MOONEY AIRCRAFT INC.
KERRVILLE, TEXAS
SERVICE LETTER 20-17

SERVICE BULLETIN M-20-17

SUBJECT: Kit-Spacer Bushings - Hook Latch

MODELS AFFECTED: M-20 Serial No. 1081 thru no 1111

Figure 1

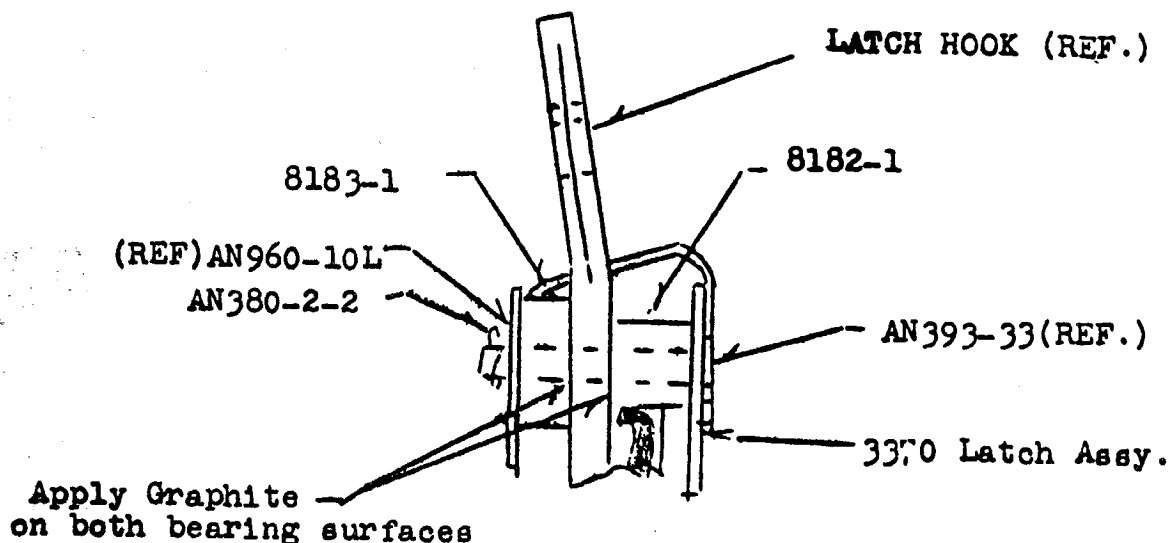
Several cases have been found where normal wear has caused excessive play to develop in the latch hook on the cabin door, permitting the hook to ride over or under the door opening frame. This can result in damage to the hook. To reduce wear and play the small bushings and washers used on the latch assemblies of the models affected are now being replaced on the production line with bushings having a larger bearing surface. These bushings are enclosed without charge for installation on units in the field.

Remove sheet metal screws attaching latch cover plate to door and two machine screws under door gasket. This should allow the latch to be pulled down far enough to remove clevis pin through slot in latch hook (Figure 1).

Remove and discard the two bushings and washers spacing the latch hook. Install enclosed bushings as shown. Replace Latch assembly with the two machine screws and replace sheet metal screws in cover plate. Replace upholstered panel and screws in upper part of window molding.
